SUBJECT: REACTOR WATER LEVEL INSTRUMENTATION CHANNEL CHECK

Re: Oyster Creek Nuclear Generating Station

Amendment No. 95
License No. DPR-16

SAFETY EVALUATION BY THE OFFICE OF NUCLEAR REACTOR REGULATION
SUPPORTING AMENDMENT NO. 95 TO PROVISIONAL OPERATING LICENSE NO. DPR-16

GPU NUCLEAR CORPORATION OYSTER CREEK NUCLEAR GENERATING STATION UPDATED FINAL SAFETY ANALYSIS REPORT	REACTOR WATER LEVEL INSTRUMENTATION	
	REV. 0, 12/84	FIGURE 7.6-3

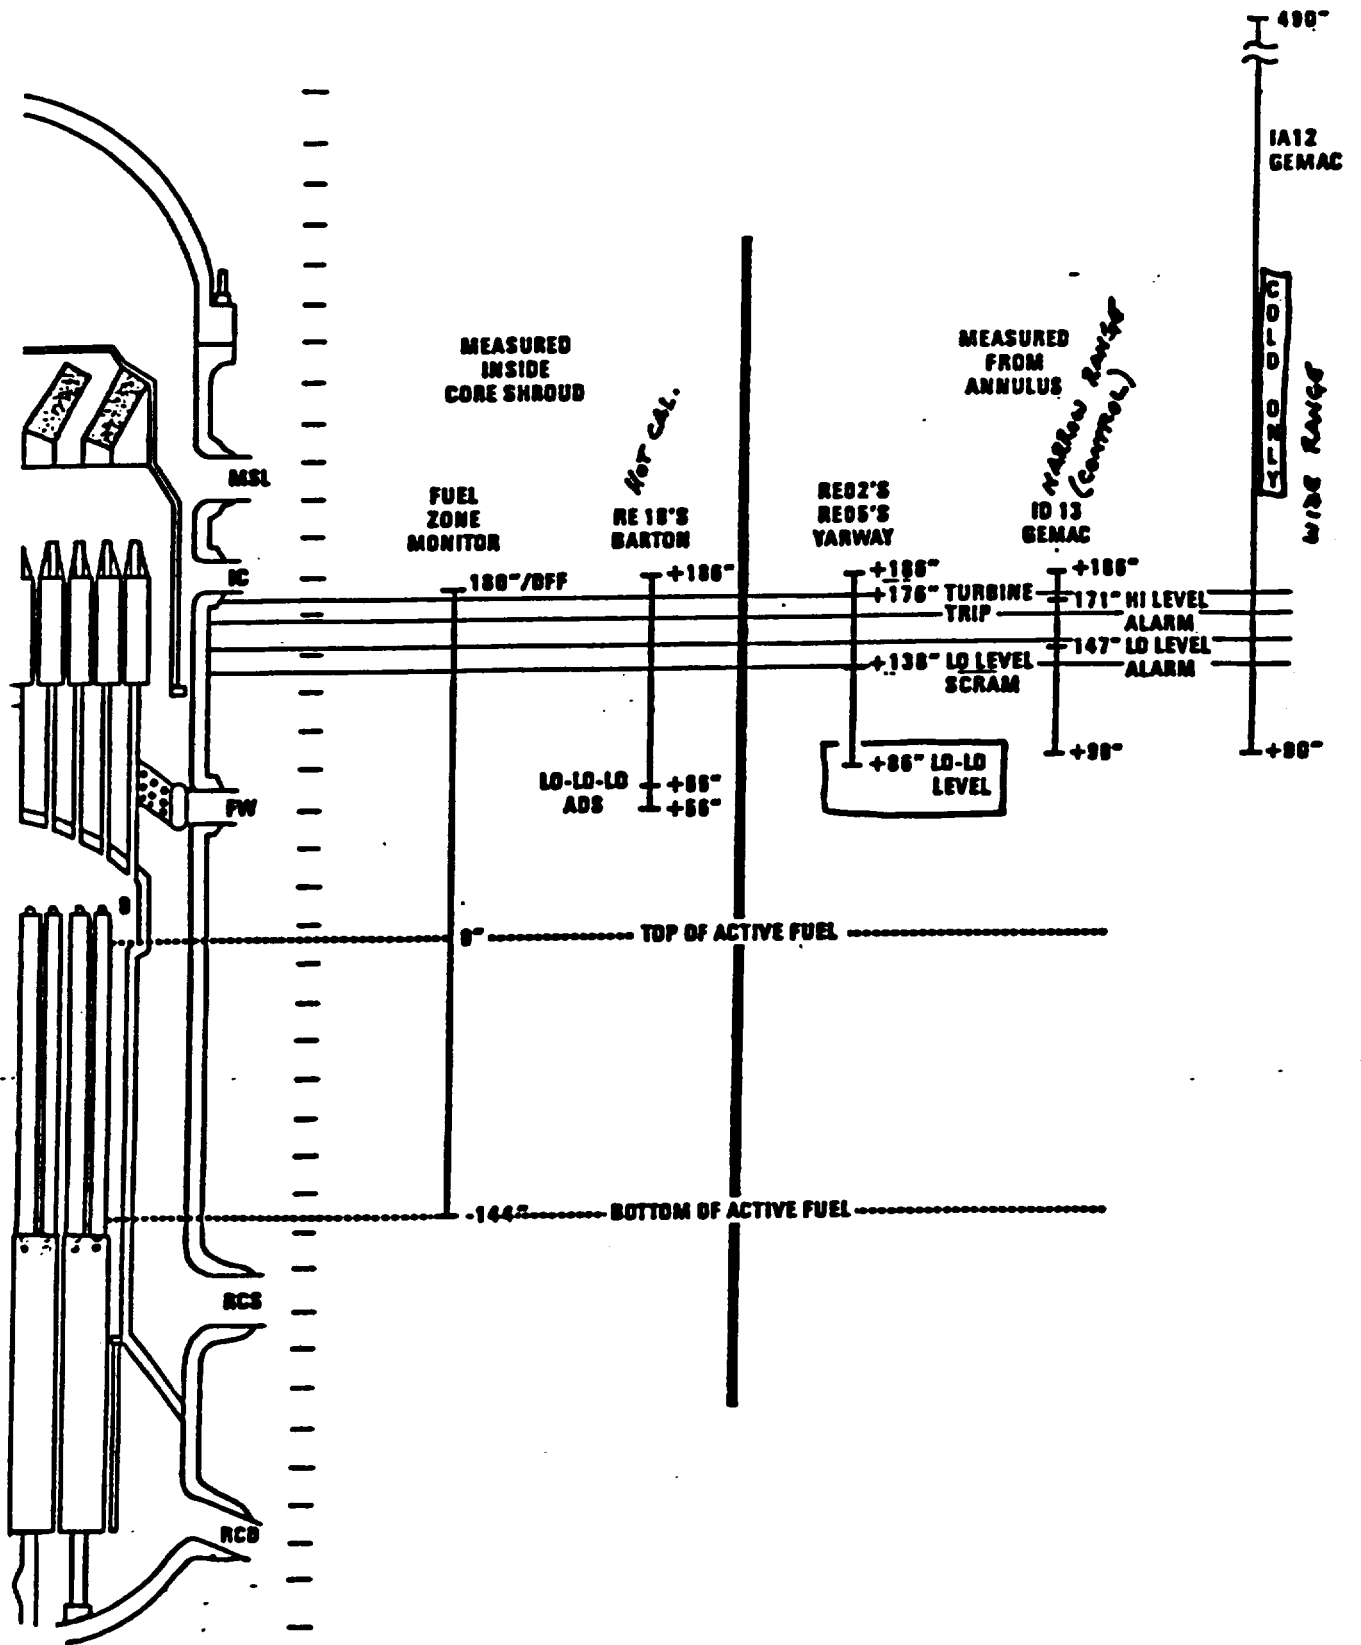
The licensee's planned equipment changes were conducted with the plant in cold shutdown and included replacing the transmitters and rerouting of the hydraulic sensing lines within the instrument racks for all the channels in the first and third types presented above. In replacing the transmitters in the third type presented above, the eight switches installed for low and low-low reactor water level do not have indicating gauges as the previous switches had. The action by the instrumentation channels at low reactor water level is to scram the reactor and trip the turbine. The action at low-low reactor water level is to initiate engineered safety feature systems as core spray, containment spray, reactor building isolation, etc.

The eight instrumentation channels which are the subject of this action are part of the Yarway Reactor Water Level Instrumentation System. This is the third type of water level instrumentation discussed in Section 2.0 above. This System is two completely separate level instrumentation systems so that one system could fail without causing the failure of the other. Of the instrumentation channels involved in this action, half are in each system and are connected to a manifold in each system. This system has eight channels with switches and two without switches. These eight switches provide the automatic safety action at low and low-low reactor water level. These eight channels now have no indication but the two channels without switches - now labelled RE-21A and RE-22B - still have control room indication. One of the two channels that will still have an indicating gauge in the control room will be connected to each manifold. Therefore, the channel check on these two indicating gauges will perform the purposes of a channel check on the instrumentation channels from the reactor vessel to the two manifolds. The channel check can not be done on the channels from the manifold to the switches. At the request of the staff, the licensee amended, by letter dated November 7, 1985, its application of September 30, 1985, to propose a daily channel check for channels RE-21A and RE-218.

The licensee has replaced all eight of the low and low-low reactor water instrumentation channel indicating switches with non-indicating switches. These new switches do not have indicating gauges available so that a channel check may be made on the instrumentation channel. The staff reviewed the proposed changes against the guidance provided in the Standard Review Plan and the General Design Criteria (notably GDC 21). An instrumentation channel for which a channel check cannot be performed is within the staff's acceptance criteria with respect to the reactor protection system and engineered safety features systems as specified in the Standard Review Plan, Section 7.2, Reactor Trip System, and Section 7.3, Engineered Safety Features Systems, and in the Integrated Plant Safety Assessment Report (IPSAR, NUREG-0822 dated January 1983) for Oyster Creek for the staff's Systematic Evaluation Program. The Institute of Electrical and Electronic Engineers (IEEE) Standard 270-1971 allows for instrumentation channels to not have a channel check. In addition, other protective instrument channels in TS Table 4.1.1 lack the capability of a channel check.

Based on the above, the staff concludes that the proposed amendment of November 16, 1985, to revise the TS requirements on the channel check for the low and low-low reactor water level instrumentation channels is acceptable. The frequency of the channel check for the channels (i.e. RE-21A and B) with indicating gauges is not being changed by this action.
